OTWAY WATER BOOK 26

Part A and Part
A Look at Barwon Water's New
Monitoring Program.

**Review & Comment on a
report**

**prepared for Barwon Water
by SKM, Ecology Australia &
Latrobe University, 2012.
Barwon Downs Monitoring
Program.**

Figure 3. MAP SOURCE: Appendix F SKM 2013. Points 1-4 recommended ecological & FLOWS monitoring sites.

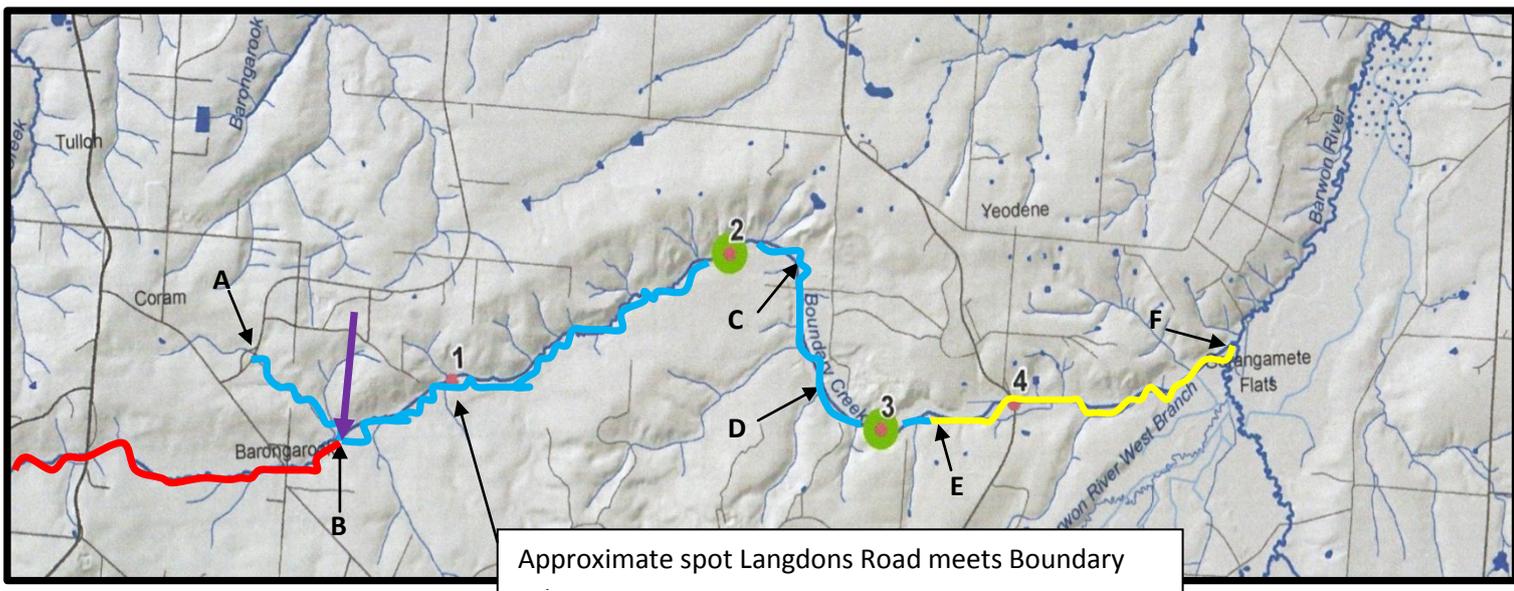
In an effort to sort out the statements made and to clarify discussion, three coloured reaches have been superimposed on the SKM map as seen above. The upper reach being the dry section of Boundary Creek above the artificial supplementary flow releases from the Otway to Colac Pipeline. The blue reach between points B and E is called the middle reach, impacted by the artificial supplementary flows. The yellow section being the dry creek bed down to the confluence with the Barwon River.

On page 85 of the 2013 SKM Report, at Boundary Creek on Langdons Road, it is stated that this is the first part of the stream that appeared to have perennial flow. From page 139, Appendix G, of the 2013 SKM Report it appears that this point is Site 1. However, to fit in with the description of the Langdons Road site, Site 1 would fit better if it was further upstream as indicated by the purple arrow. *“The point we accessed appeared to have a main channel entering from the north that carried most of the flow. A relatively still backwater was present in the other channel upstream of that point...”* The artificial flows from the Otway to Colac Pipeline is the only source of water that would give the impression of a perennial flow and this would come from the north down Sandy Creek from Point A. The still backwater can only be the main channel of Boundary Creek.

Fourthly, is the location of Site 2, as seen above in Figure 3, page 34, marked in the correct spot. If it is then it would not appear to be at the SFGS site.

The 2013 SKM Report recommends that 4 sites have macroinvertebrate studies carried out (see figure 3 page 34). Three of these sites fall under the influence of artificial supplementary flows and are not anything like site representative of the natural flow. Because these 3 sites have a continual flow maintained by the artificial supplementary flows, one would anticipate that any macroinvertebrates within this section of Boundary Creek would be sustained as a result of an unnatural man made ecological state. Pre artificial supplementary flows to this middle reach of Boundary Creek, the water would stop flowing during the summer months with springs and soak flow only being enough to sustain pools and dams.

Figure 4.

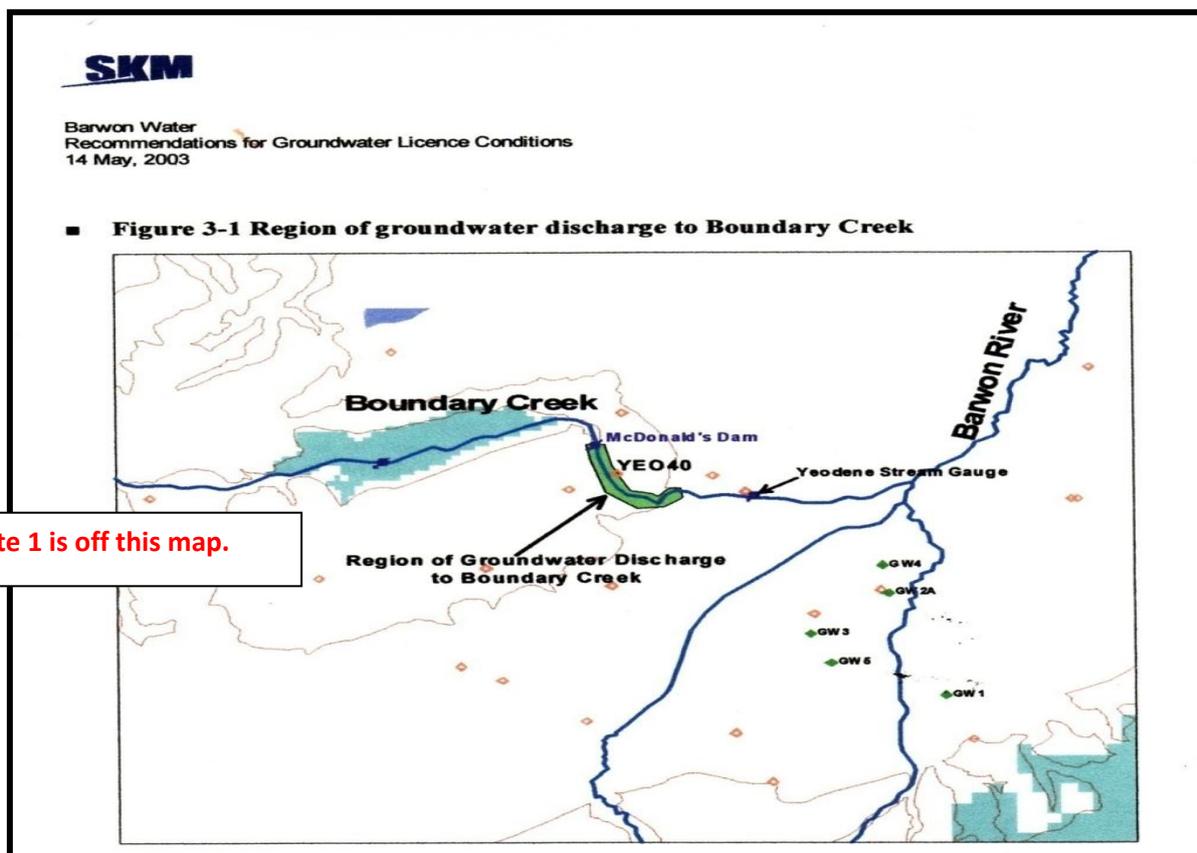
Not so long ago in 2003, SKM produced this map (Figure 4) that clearly defines where the groundwater discharges into Boundary Creek creating a perennial creek flow. Considering observation bore decline and the impacts that have taken place in this green zone there would appear to be little doubt that this map is still representative of the “*Region of Groundwater Discharge to Boundary Creek.*” This location falls neatly between C and E as seen in figure 3, page 34. It is nowhere near Point 1 that has been described as perennial.

Under natural flow conditions Boundary Creek could only be perennial at Langdons (Point 1) if there was groundwater discharge. With Boundary Creek dry only metres above where the tributary, Sandy Creek and the artificial supplementary flows enter (see point B figure 3), it seems most unlikely that Boundary Creek is perennial at Langdons Road in this part of the middle reach. This is another reason for ceasing the artificial flows. A true indication of what is naturally occurring is being confounded by these artificial flows.

Below this dry upper reach and past the artificial input downstream... *“...groundwater contributions and inflow from small tributaries appeared to increase flow in the middle reaches (i.e. from the release point down to McDonalds Dam).”* This is the first time, ever, that there has been any suggestion that there is an increase from small tributaries in this section. This is an area well upstream of that indicated on the SKM map in Figure 4, page 35.

1. Is the 14th May 2003 SKM document showing the discharge of groundwater still applicable? (see figure 4, page 35)
2. Is it correct, to designate a reach as having a natural perennial flow kilometres upstream of the 2003 SKM discharge area? Bearing in mind the 2003 SKM discharge points and the addition of artificial supplementary flows, this seems doubtful.
3. If there is regional discharge as now suggested above the area designated in the SKM 2003 map, how was this missed in 2003?
4. Where exactly is the site of the iron bacteria?
5. Where exactly is the site of the decommissioned Stream Flow Gauging Station above McDonalds Dam?
6. Is the iron bacteria site the same as the upstream SFGS?

Figure 5. MAP SOURCE: Appendix F SKM 2013. (The approximate sites of the 1994 Flora survey, in red, have been added.)

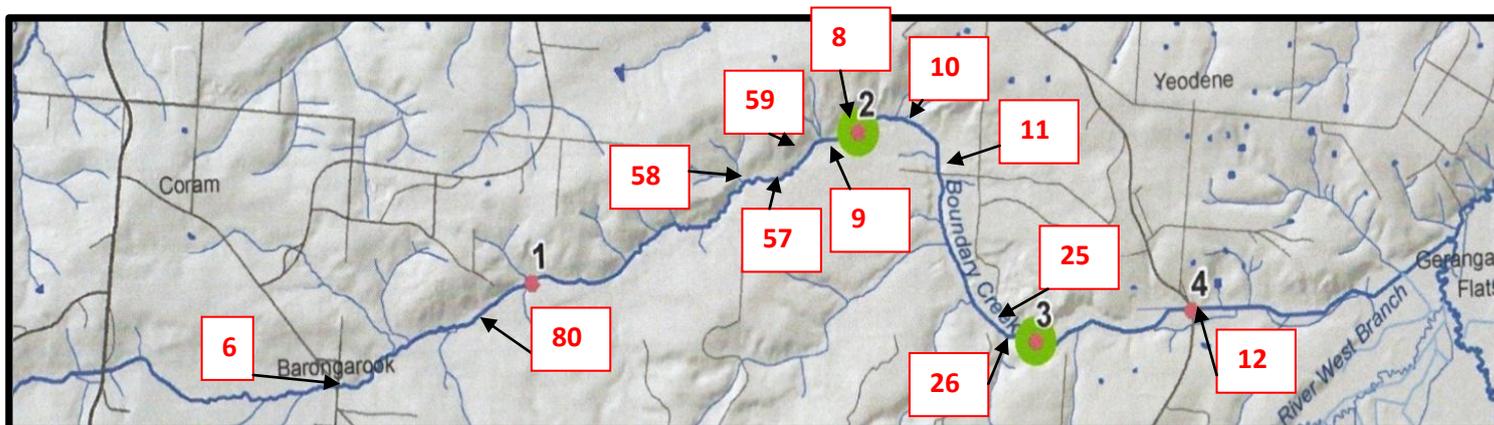
It would appear that there is quite a store of recorded flora data along Boundary Creek and in the target area that has not been taken into account in the 2013 SKM Report new monitoring program. Why haven't the hydrologically sensitive vegetation sites surveyed in 1994 been included in the 2013 recommendations?

Figure 6. MAP SOURCE: Appendix E 2013 SKM Report. (Additions are the yellow stars. Two are off the map but are well within the residual drawdown influence from the Barwon Downs Borefield.)

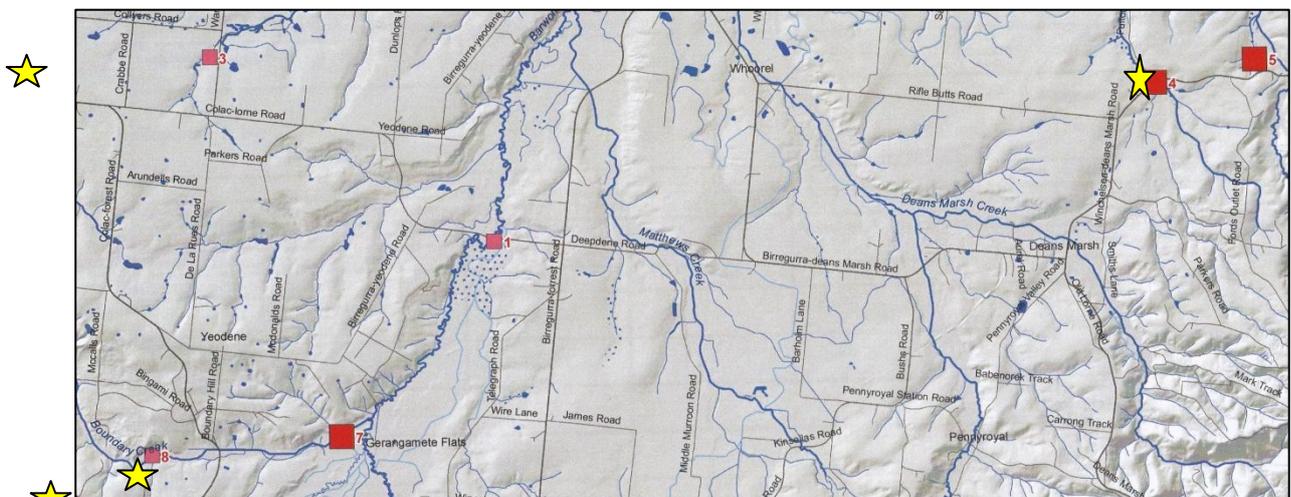
Not only are these sites known (indicated with a yellow star), they have already been tested for Acid Sulfate Soils. LAWROC has these results.

Figure 14. MAP SOURCE: State Rivers and water Supply, Victoria.⁽²⁰⁾

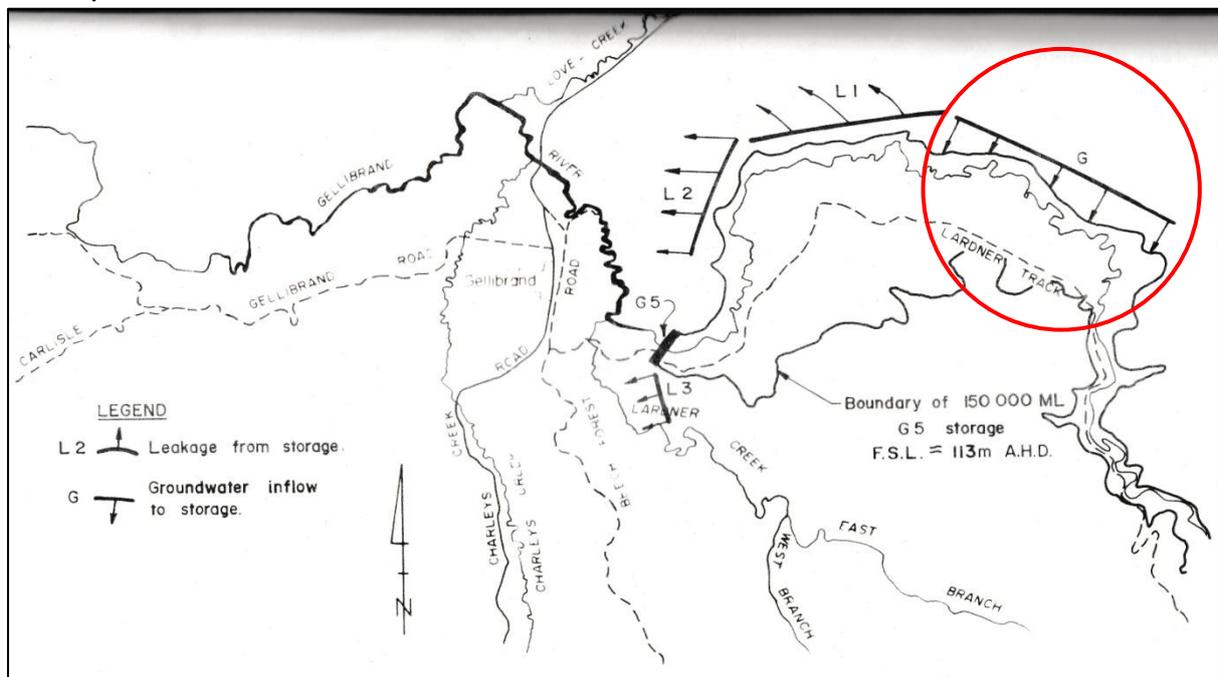
Little consideration has been given to the groundwater inflows into the upper part of the middle reaches of the Gellibrand River (see Figure 14 below). Has there been any work in regard to the sources of the groundwater that flows into this reach of the Gellibrand River? The question being does groundwater sourced from the Barongarook High flow under the Barwon Downs Borefield in a southerly direction and flow into this part of the Gellibrand River? Or is the area marked by the red circle the inflow that comes through the Loves Creek/Kawarren corridor?

3. Put in the 4 observation bores in the aquifer divide area as recommended on page 71 of Appendix A.
4. Investigate the source of groundwater inflow into the Gellibrand River through the area designated in figure 14.

Figure 15. Black lines depicting the depth of nested bores.

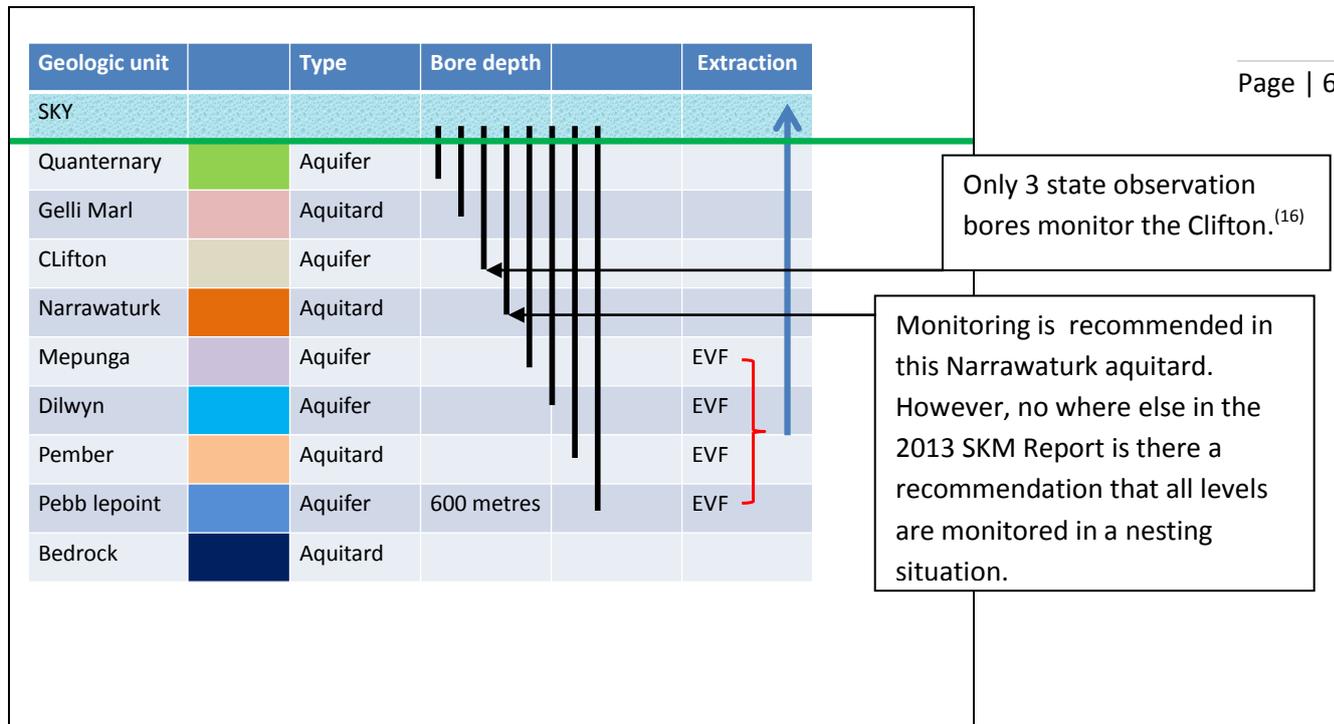
However, this is not enough. All layers above the EVF to the surface should be monitored and done using nested bores.

The effects and impacts from vertical leakage is poorly understood and will continue to be so until nested bores are drilled into all geological units from the EVF to the surface. This should be a priority and data collected should include previous modelling. Assurances that this would be done were made at the 7th meeting of the Barwon Downs Groundwater Community reference Group, 25th March 2014.
